COMMISSION OF ARCHITECTURAL REVIEW

APPLICATION FOR CERTIFICATE OF APPROPRIATENESS

Address 808 N. 21st St Richmond, VA 23223

Application #: COA-028036-2017

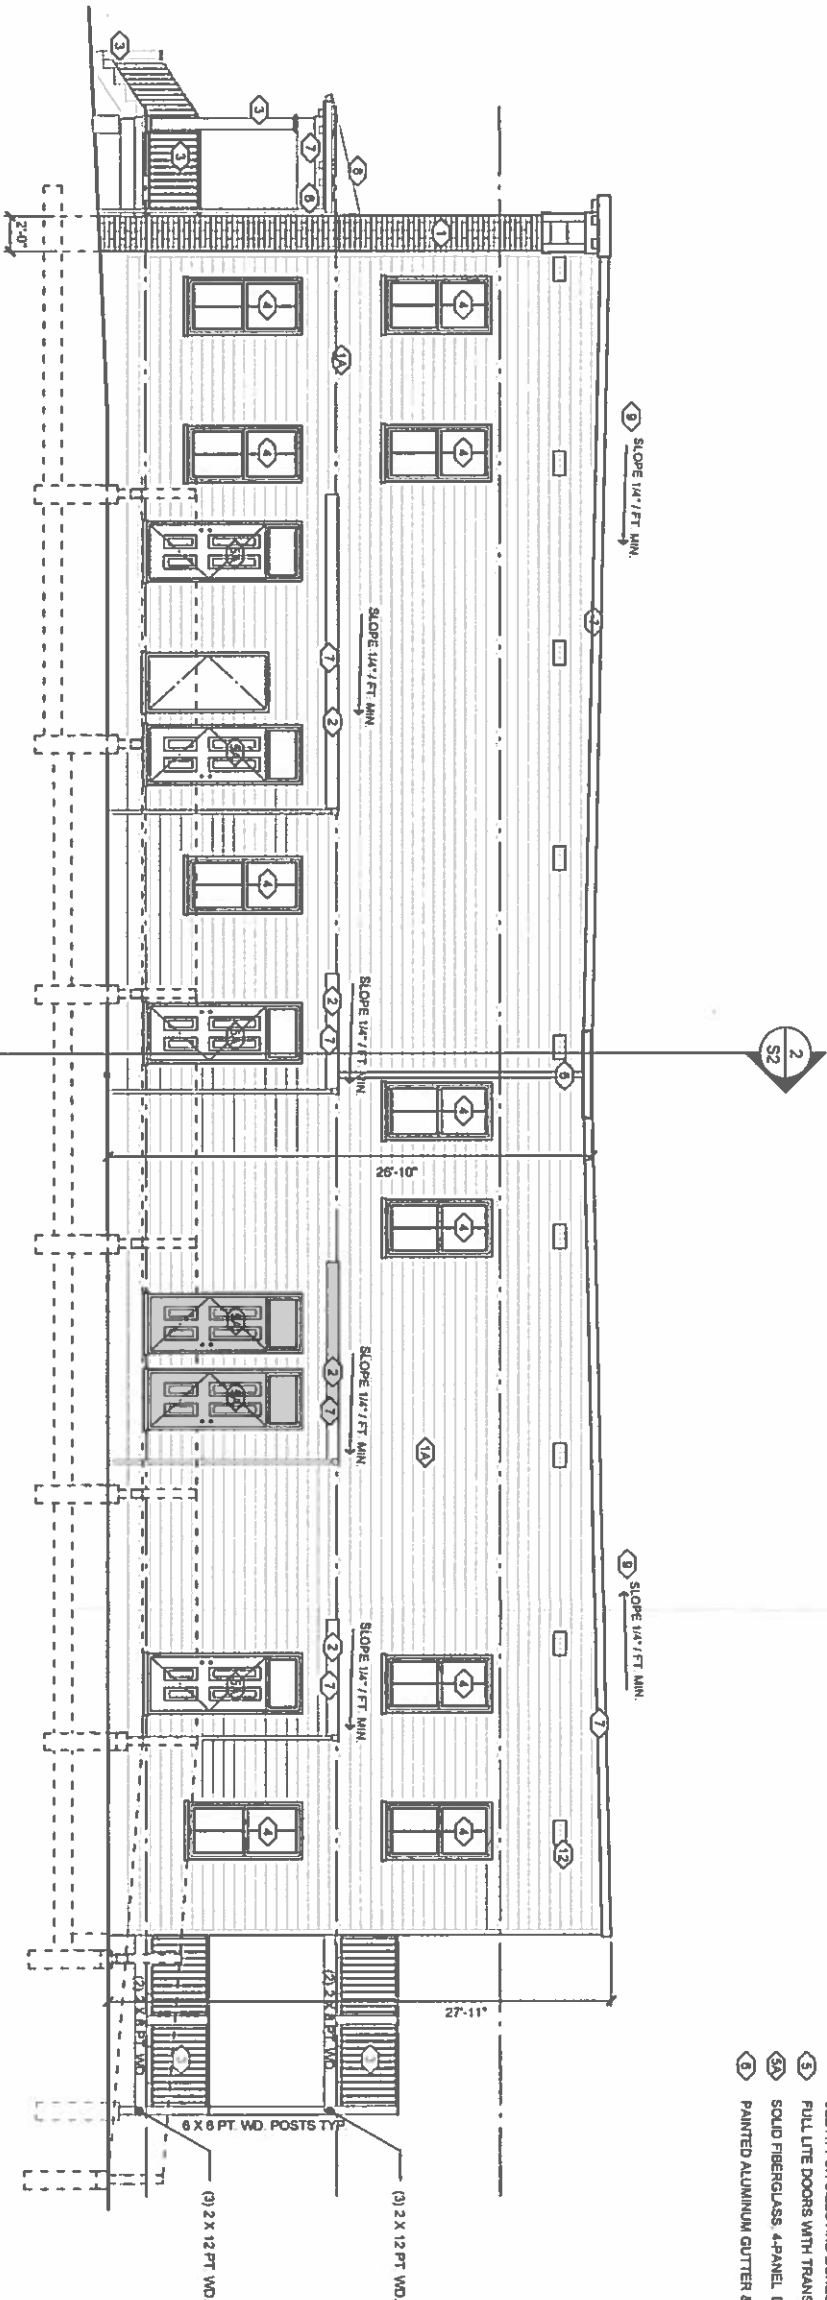
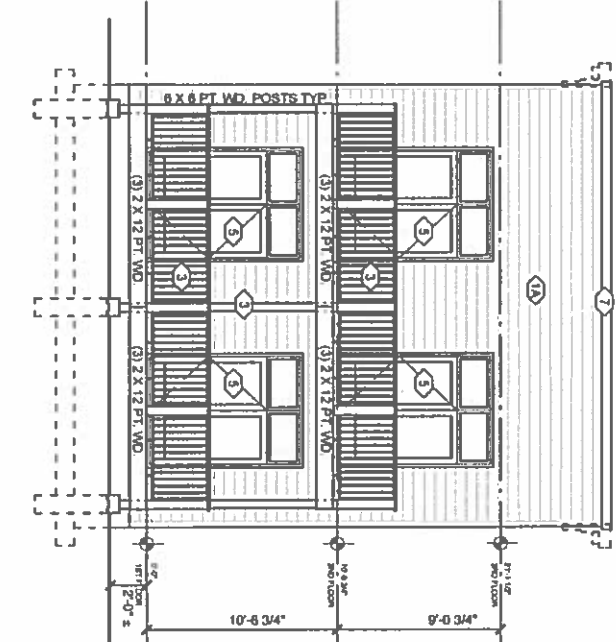
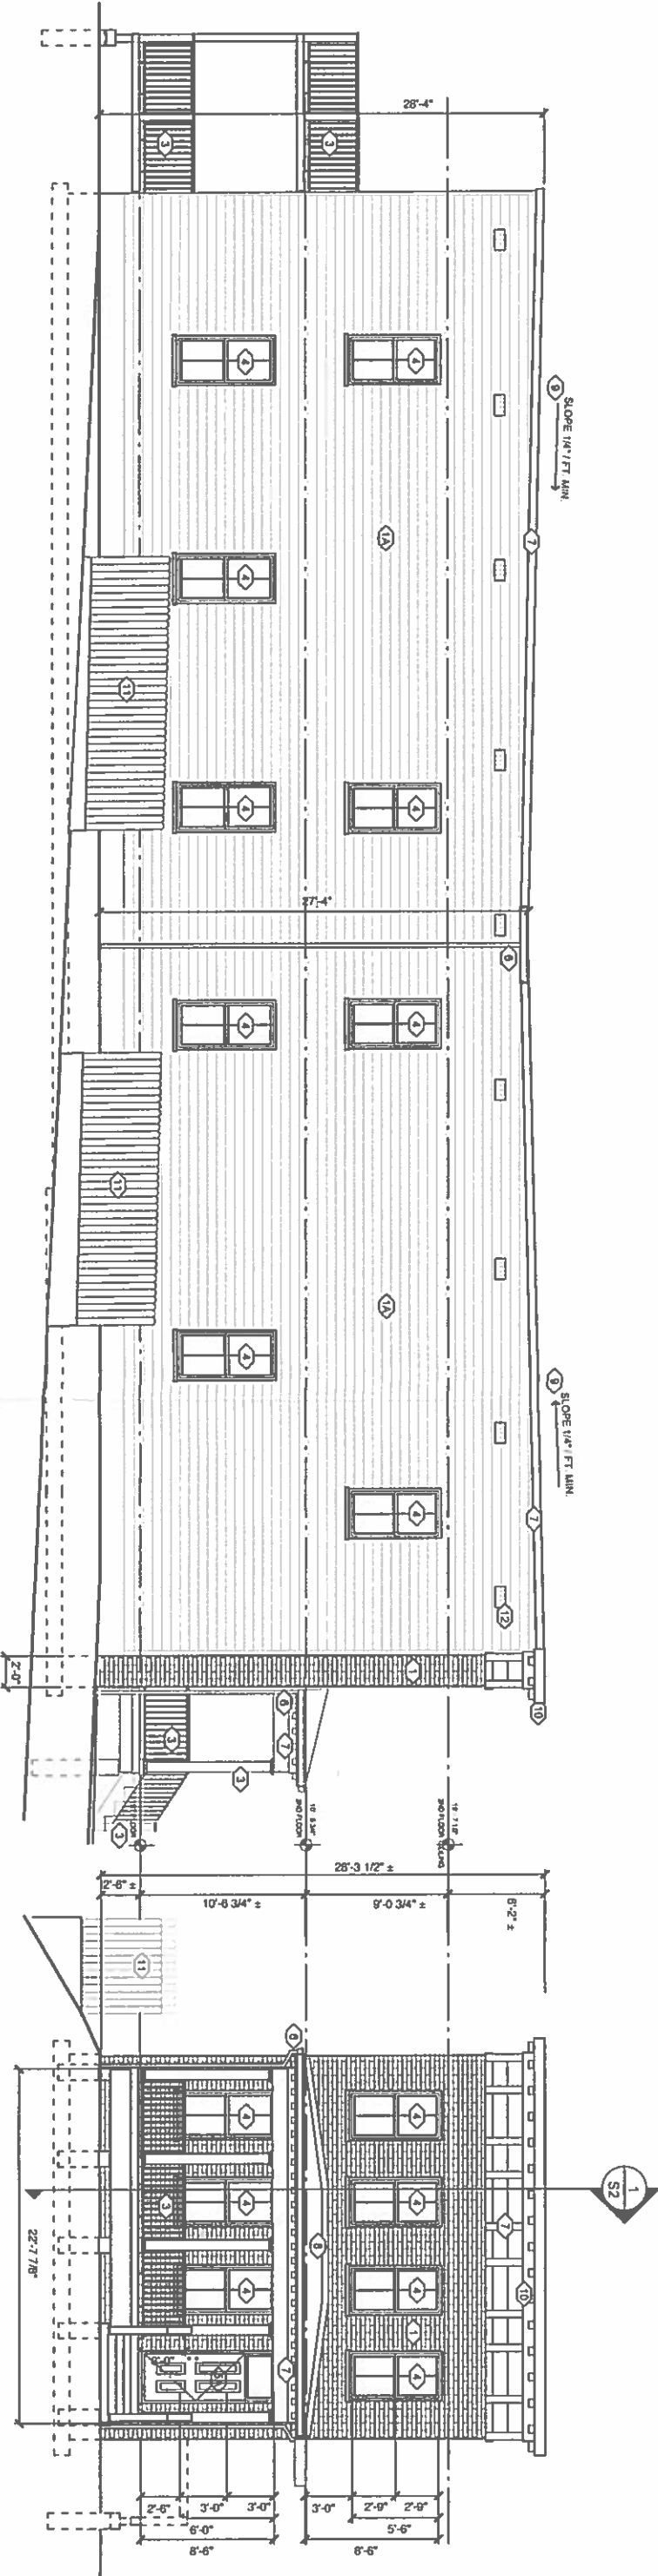
This project has already undergone extensive review and multiple CAR meetings, with an approval in the spring of 2017. This new application only seeks one modification to previously approved plans: change the sides and rear elevations back to hardie plank.

So it is my proposal now to go back to a brick front, which was the suggestion and consensus of the CAR committee at the last meeting. The brick will wrap around roughly 2 feet and then transition to smooth, 8.25" (7" reveal) hardie siding.
